GE Hitachi Nuclear Energy

MFN 08-145, Supplement 1

Docket No. 52-010

**Subject: Revised Response to RAI Number 11.2-16S01, and 11.2-16S02
and Revised DCD Pages for RAI Numbers 11.2-27, 11.3-6, 11.3-
10, 11.4-25, 11.4-29 and 11.5-49**

Figure 11.4-3. SWMS Solid Radwaste Dewatering System (Conceptual Design) Wet Solid Waste Processing Subsystem

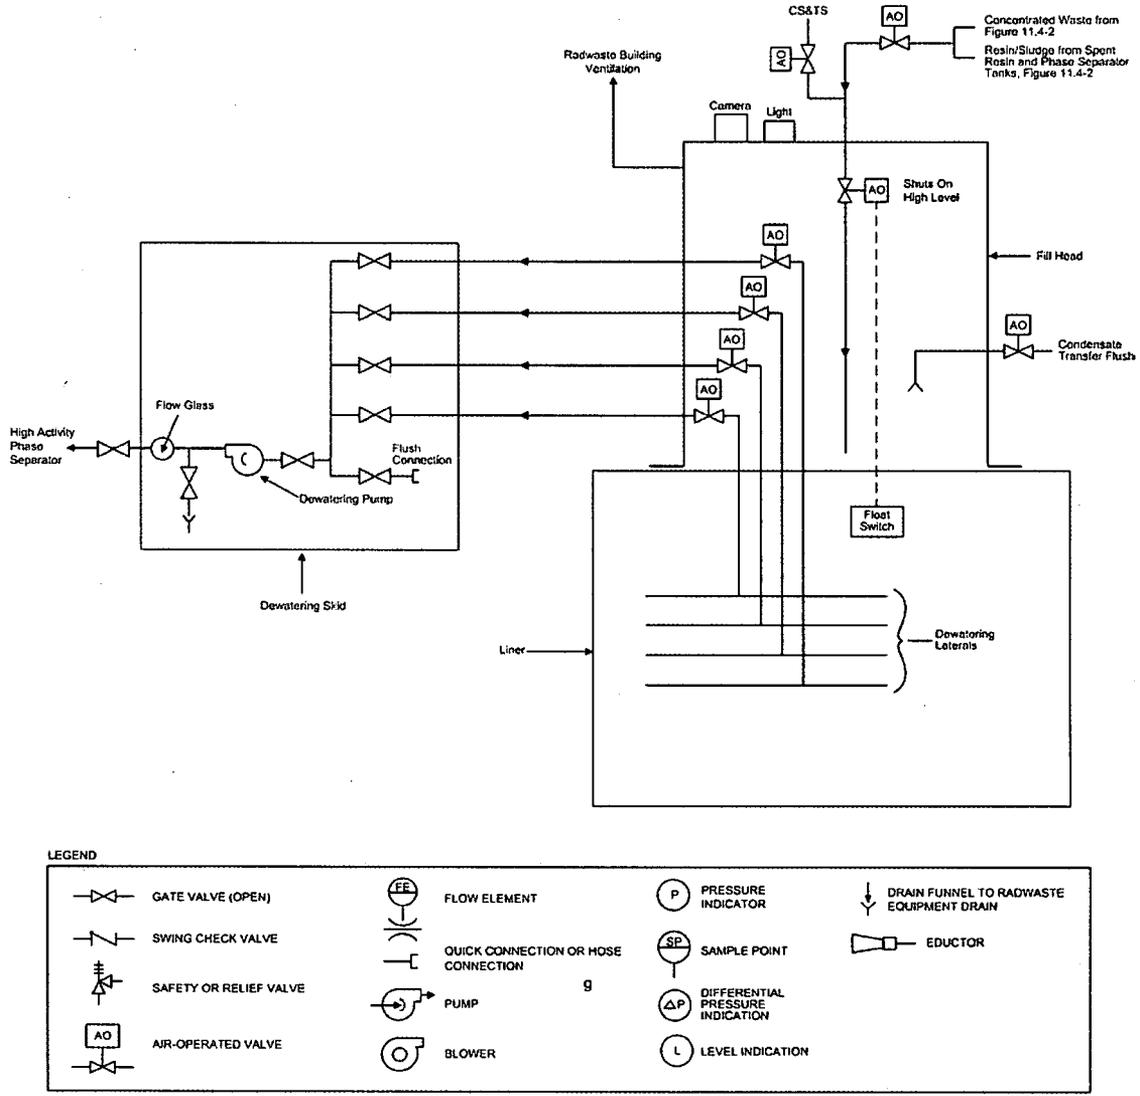
3. RAI 11.3-6 – Subsection 11.3.2.6 has been revised to reflect that the Table 3.2-1 for K30 is for the Offgas System.
4. RAI 11.3-10 – The ** note has been added to Xenon delay in Table 11.3-1.
5. RAI 11.4-25 – Figure 11.4-3 has been revised to include a vent for the Fill Head.
6. RAI 11.4-29 – Figure 11.4-4 has been revised to indicate that trash will be released under the provisions of the licensee's radiation protection program with appropriate references to U.S. NRC Circular 81-07 and Information Notice 85-92.
7. RAI 11.5-49 – Table 11.5-1, TSC HVAC response range has been revised to indicate a range of 1E-4 to 1E0 mSv/hr and 1E-2 to 1E2 mrem/hr.
